CCR-81

REQUEST FOR INFORMATION NOT ADDRESSED IN THIS CCO REMAIN IN FORCE

SAS SUPERSTRUCTURE ROADWAY WESTBOUND
LIGHTING AND ELECTRICAL SYSTEMS

SKETCH No. CCR-81-SK-E-46 R1

E-46

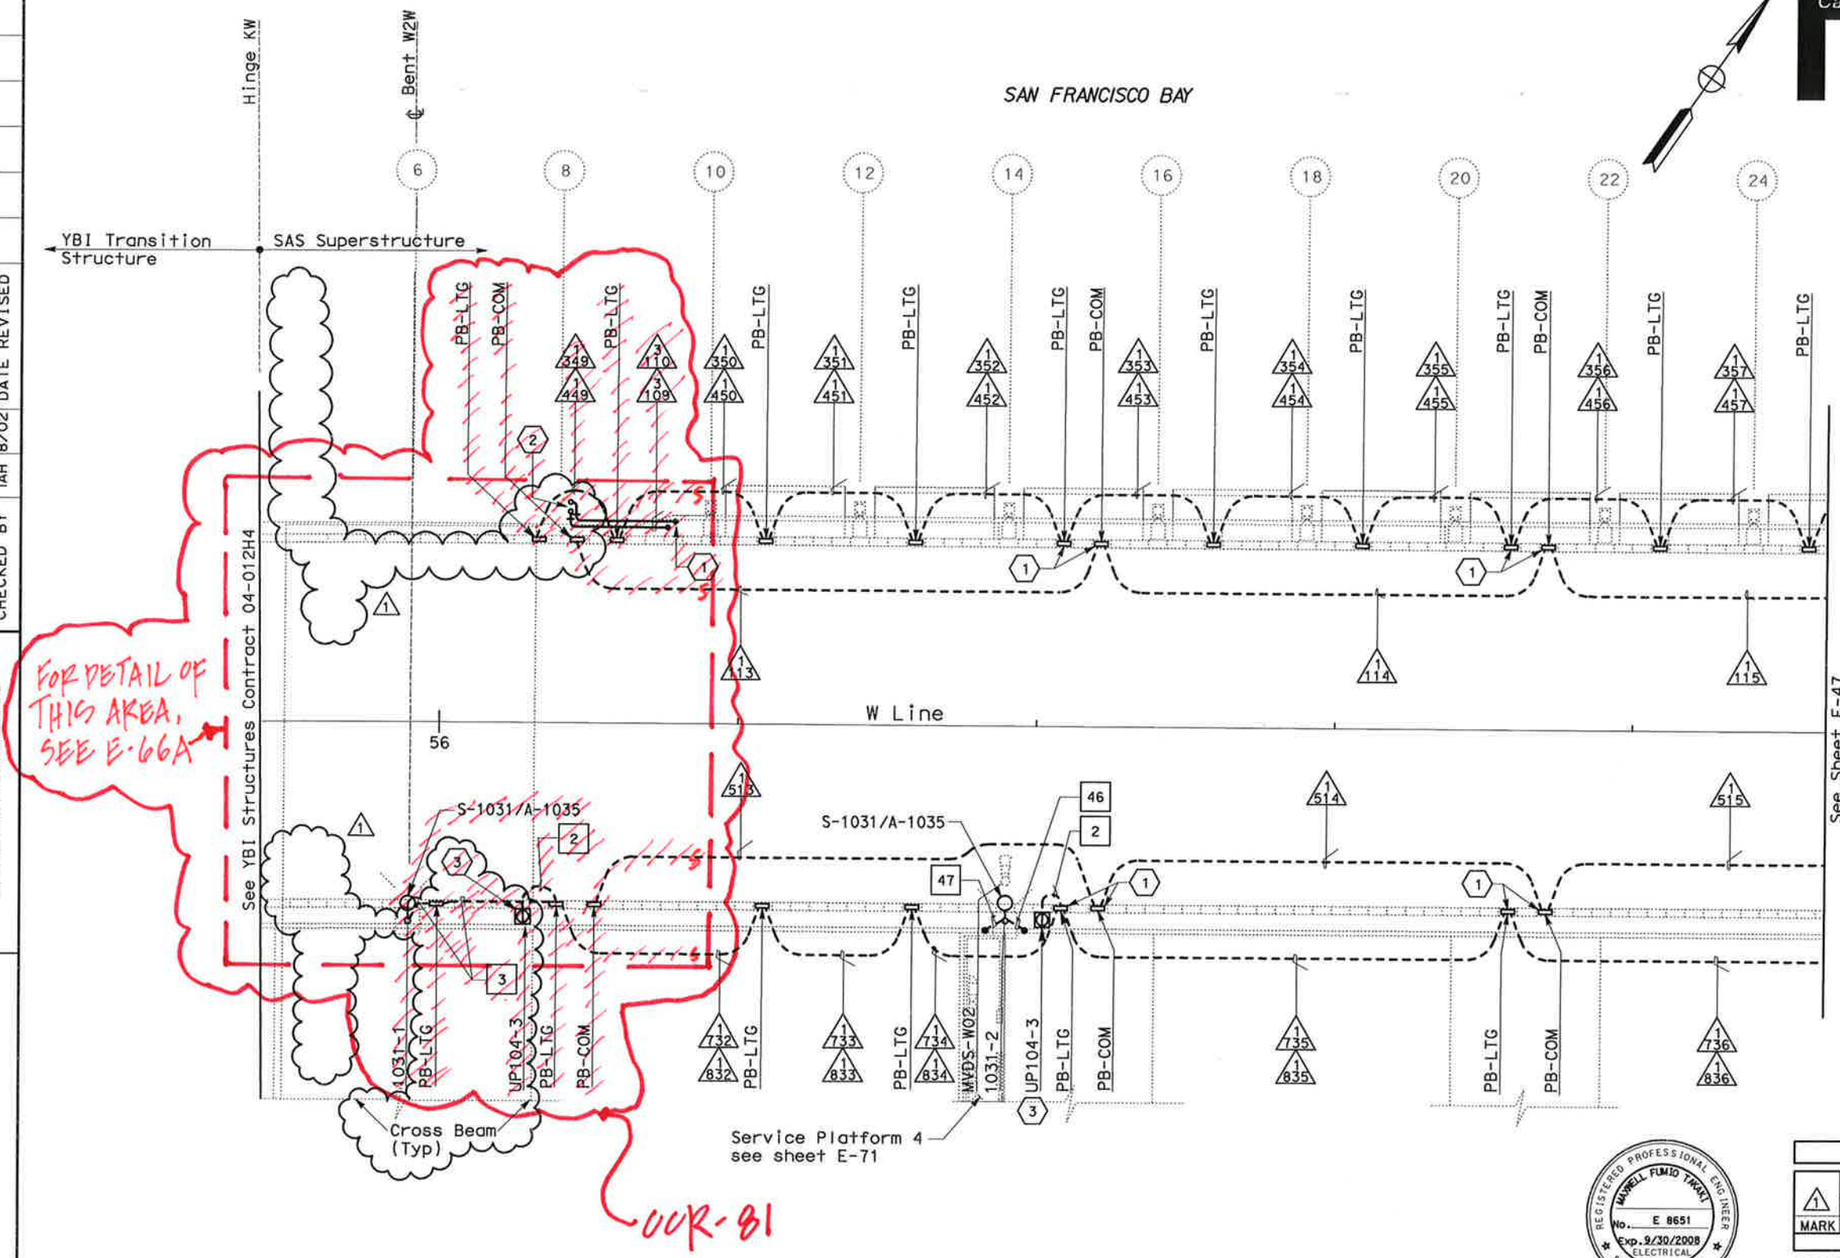
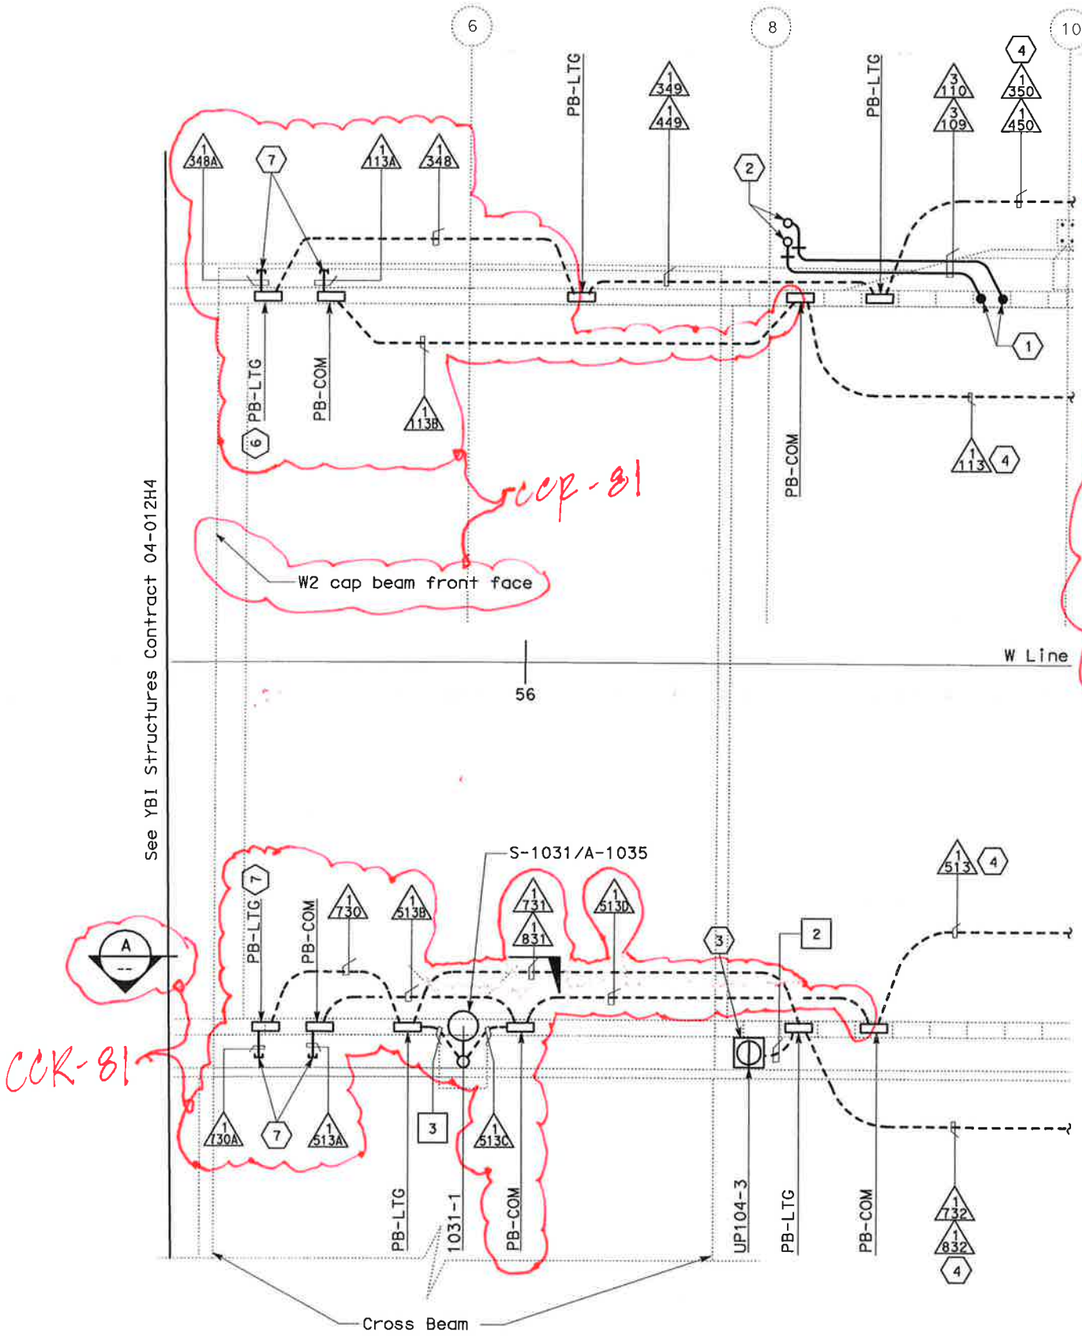
1. Conduit from barrier pullbox or other equipment down into Girder, see sheet E-96.
2. For conduit to Suspend Lighting, see sheet E-226. Typ for all PB-LTG located on the north side of the roadway.
3. Roadway Barrier Receptacle, see Detail 1, sheet E-68.

E-66A

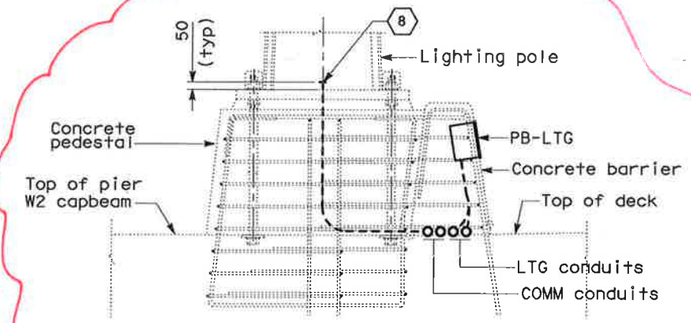
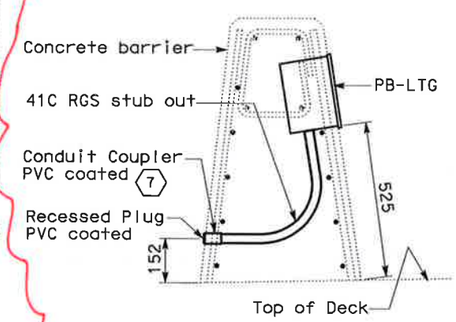
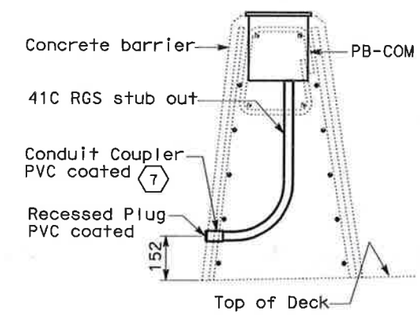
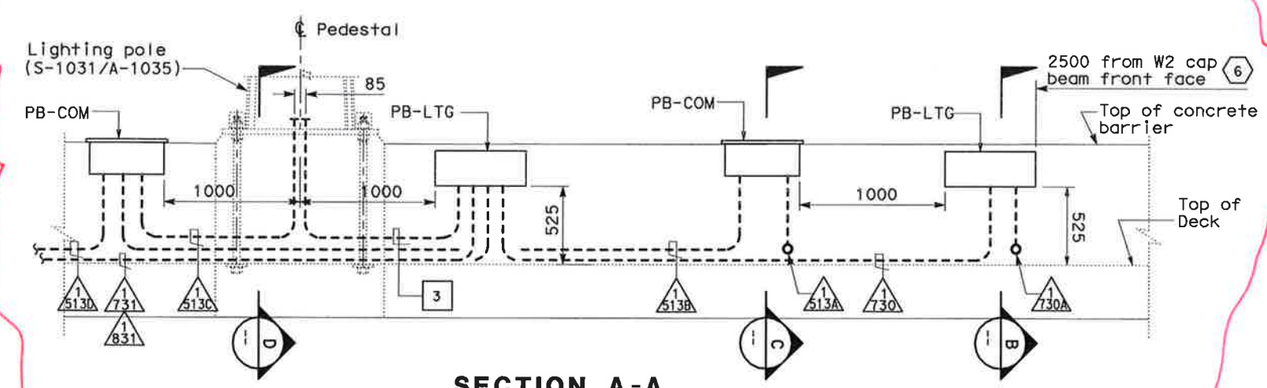
1. Conduit from barrier pullbox or other equipment down into Girder, see sheet E-96.
2. For conduit to Suspend Lighting, see sheet E-226. Typ for all PB-LTG located on the north side of the roadway.
3. Roadway Barrier Receptacle, see Detail 1, sheet E-68.
4. See drawing E-46 for continuation of conduits.
6. Contractor shall verify dimension and locate PB-LTG with sufficient distance to accommodate required clearance for the expansion joint.
7. Conduit shall be stub-out at the non-roadway side of the barrier with the coupler flushed to the barrier face wall.
8. Capped end of conduit stub-ups.

Similar for installation of PB-LTG and PB-COM on north side concrete barrier.
Conduit routing varies, see conduit plan.

E-96

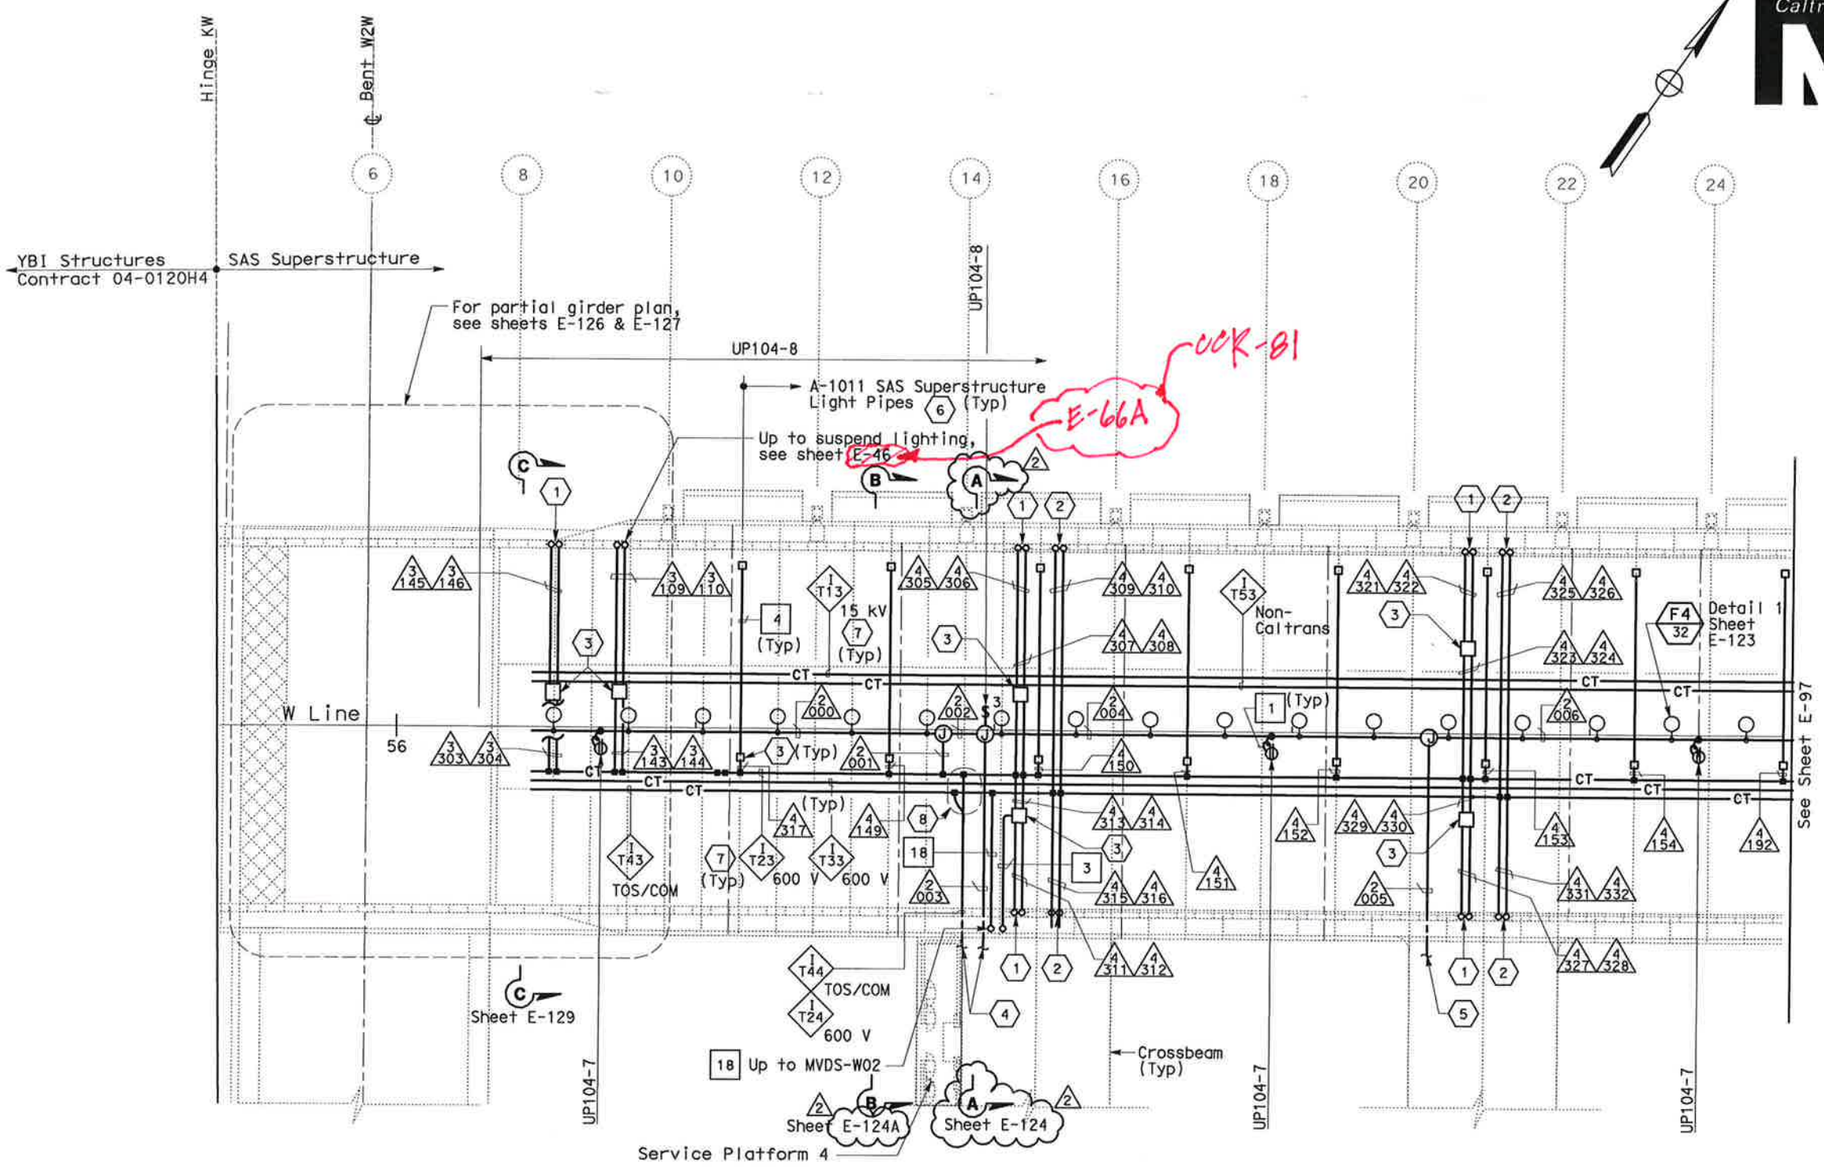
1. Conduit up to PB-LTG located in barrier, see sheet E-46.
2. Conduit up to PB-COM located in barrier, see sheet E-46.
3. PB-2A locate on top of floor.
4. For cable tray run and lighting inside crossbeam, see sheet E-114.
5. For lighting inside crossbeam, see sheet E-119.
6. PB-2L with circuit for future light pipes. See sheet E-121 for installation details and E-130 for lighting schedule.
7. For cable tray & ground bar support, refer to sheet E-125.
8. For fiber splice tray detail, refer to sheet E-356.

E-135

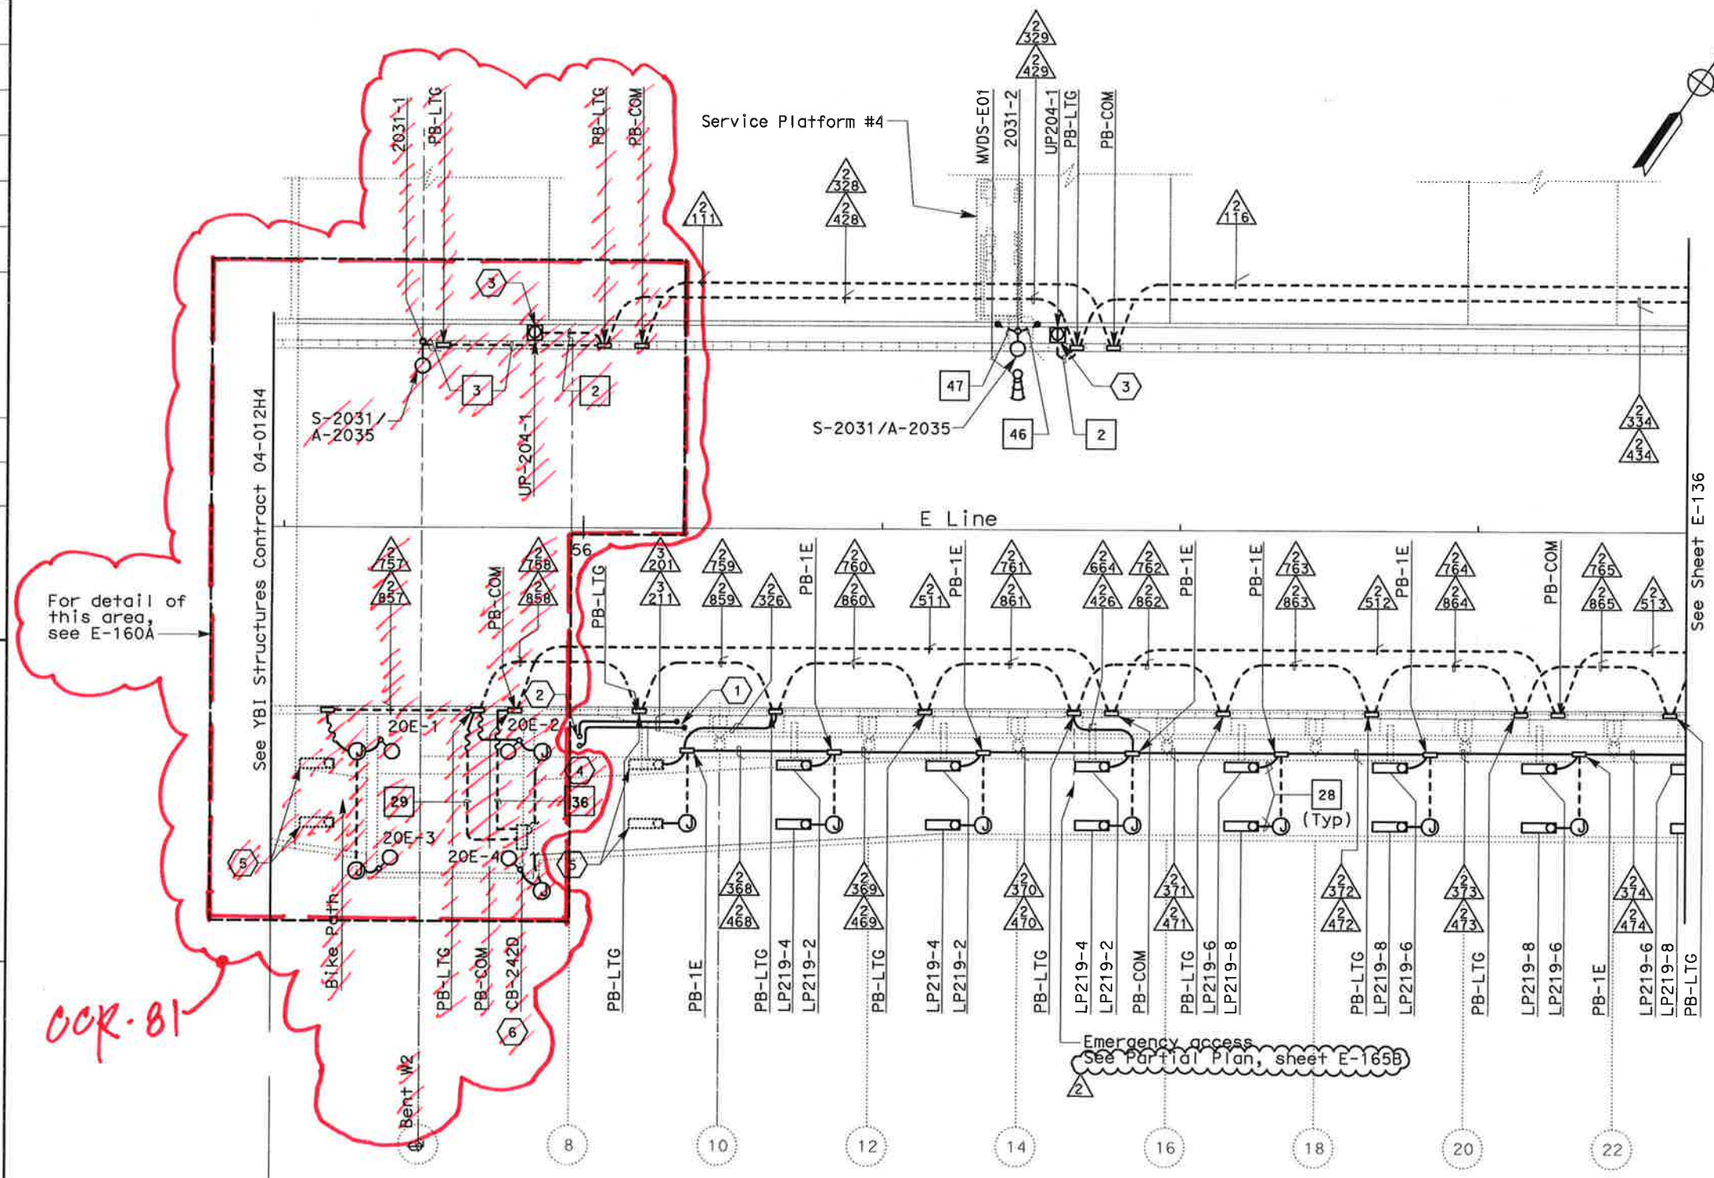
1. Conduit from barrier pull box or other equipment down into Girder Box, see sheet E-181.
2. For conduit to suspension cable lighting, see sheet E-226.
3. Roadway Barrier Receptacle, see Detail 1, sheet E-162.
4. Contractor shall coil 30 meters inside cable tray for feed into PB-COM by others. CCR-81
5. Railing lights are contractor furnished and installed by others.
6. Bike path electrical components west of PP-9 are furnished by contractor and installed by others.
7. 41C Rigid Galvanized Steel with PVC coated coupler and plug that stub-out at the non-roadway side of the barrier. Coupler shall be flushed to the barrier face wall.
